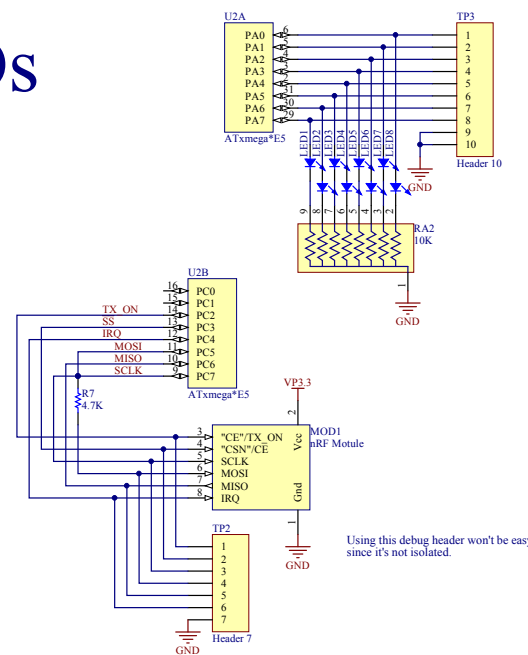
R30 is to allow more creepage when used with 240V. It's 0R for 120V

Possibly use a smaller inductor for L2?  
It still has high pulsed currents at startup

Possibly find another regulator that can handle cheaper output caps?
